**TSG-RAN Meeting #14
Kyoto, Japan, 11 - 14, December, 2001**

TSGRP#14(01) 0849

Title: Agreed CRs to TS 25.413

Source: TSG-RAN WG3

Figure 1: Location Report procedure. Successful operation.

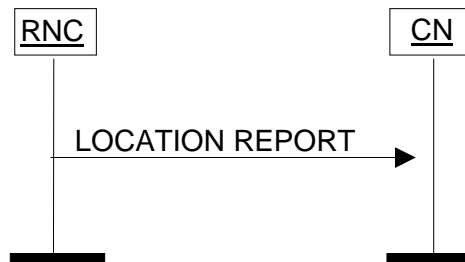
Reason for change:	⌘ The "Requested Report type not supported" cause value should be renamed since it is actually intended to be used not only to indicate the fact that the type of location information to be reported (report area) cannot be met but has a wider scope.
Summary of change:	⌘ Cause value "Requested report type not supported" renamed "Requested request type not supported" together with clarification text.
	<p>Impact Analysis:</p> <p>Impact assessment towards the previous version of the specification (same release): This CR has isolated impact with the previous version of the specification (same release) because previous implementations may have not been clear when to indicate an undetermined location with the cause "report type not supported".</p> <p>This CR has an impact under protocol/functional point of view. The impact can be considered isolated because the change affects one system function, i.e. location reporting.</p>

If the RNC can not deliver the location information as requested by the CN, [due to either the non-support of the requested event or the non-support of the requested Report Area](#), the RNC shall indicate the UE location to be "Undetermined" by omitting the *Area Identity* IE. A cause value shall instead be added to indicate the reason for the undetermined location, e.g. "Requested ~~Requestport~~ Type not supported". If the *Cause* IE is set to "Requested ~~Requestport~~ Type not supported" the *Request Type* IE shall be included as a reference of what [is the requestport type that](#) is not supported.

Figure 1: Location Report procedure. Successful operation.

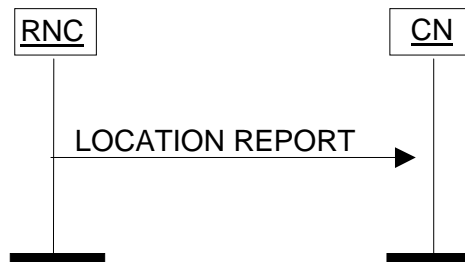
Reason for change:	⌘ The “Requested Report type not supported” cause value should be renamed since it is actually intended to be used not only to indicate the fact that the type of location information to be reported (report area) cannot be met but has a wider scope.
Summary of change:	⌘ Cause value “Requested report type not supported” renamed “Requested request type not supported” together with clarification text.
	<p>Impact Analysis:</p> <p>Impact assessment towards the previous version of the specification (same release): This CR has isolated impact with the previous version of the specification (same release) because previous implementations may have not been clear when to indicate an undetermined location with the cause “report type not supported”.</p> <p>This CR has an impact under protocol/functional point of view. The impact can be considered isolated because the change affects one system function, i.e. location reporting.</p>

If the RNC can not deliver the location information as requested by the CN, [due to either the non-support of the requested event or the non-support of the requested report area](#), the RNC shall indicate the UE location to be "Undetermined" by omitting the *Area Identity* IE. A cause value shall instead be added to indicate the reason for the undetermined location, e.g. "Requested ~~Requestport~~ Type not supported". If the *Cause* IE is set to "Requested ~~Requestport~~ Type not supported" the *Request Type* IE shall be included as a reference of what [is the requestport type that](#) is not supported.

Figure 36: Protocol Errors in RANAP.

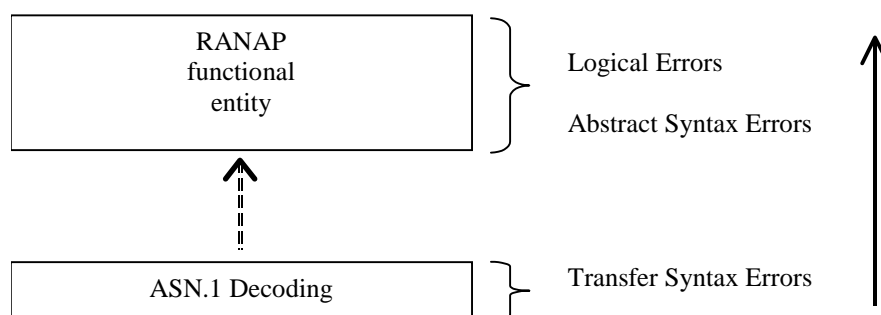
Reason for change:	⌘ If the receiver detect an error (e.g. transfer syntax error, abstract syntax error) in the receiving message but there is no unsuccessful response message to report the error, the Error Indication procedure is specified to use to report the error. The <i>Procedure Code</i> IE and the <i>Triggering Message Criticality</i> IE in the <i>Diagnostics</i> IE is specified to include in the Error Indication procedure so that the sender who sent the erroneous message can understand which procedure had the error. However, this was not clearly specified in error cases such as “transfer syntax error (Subclause 10.2)”, “not comprehended Type of Message IE (Subclause 10.3.4.1A)” and “IEs or IE groups received in wrong order or with too many occurrences or erroneously present (Subclause 10.3.6)”. This could lead to a situation e.g. the sender who sent the erroneous message can not understand what was the Error Indication procedure corresponding to and cause the traffic load if the sender resent the initiating (erroneous) message unlimitedly. Other corrections are needed in the case of “Ignore and Notify Sender” and “Notify” in Missing IE or IE group (10.3.5) to have consistency description with 10.3.4.2.

[The information stated in subclauses 10.2, 10.3 and 10.4, to be included in the message used when reporting an error, is what at minimum shall be included. Other optional information elements within the message may also be included, if available. This is also valid for the case when the reporting is done with a response message. The latter is an exception to what is stated in subclause 4.1.](#)

Figure 38: Protocol Errors in RANAP.

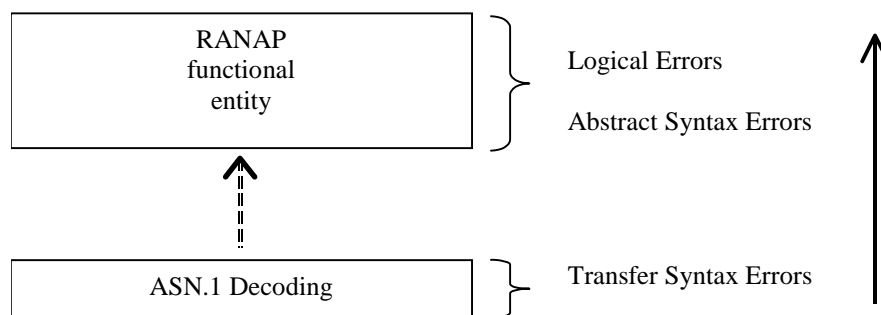
Reason for change:	⌘ If the receiver detect an error (e.g. transfer syntax error, abstract syntax error) in the receiving message but there is no unsuccessful response message to report the error, the Error Indication procedure is specified to use to report the error. The <i>Procedure Code</i> IE and the <i>Triggering Message Criticality</i> IE in the Diagnostics IE is specified to include in the Error Indication procedure so that the sender who sent the erroneous message can understand which procedure had the error. However, this was not clearly specified in error cases such as “transfer syntax error (Subclause 10.2)”, “not comprehended Type of Message IE (Subclause 10.3.4.1A)” and “IEs or IE groups received in wrong order or with too many occurrences or erroneously present (Subclause 10.3.6)”. This could lead to a situation e.g. the sender who sent the erroneous message can not understand what was the Error Indication procedure corresponding to and cause the traffic load if the sender resent the initiating (erroneous) message unlimitedly. Other corrections are needed in the case of “Ignore and Notify Sender” and “Notify” in Missing IE or IE group (10.3.5) to have consistency description with 10.3.4.2.

[The information stated in subclauses 10.2, 10.3 and 10.4, to be included in the message used when reporting an error, is what at minimum shall be included. Other optional information elements within the message may also be included, if available. This is also valid for the case when the reporting is done with a response message. The latter is an exception to what is stated in subclause 4.1.](#)
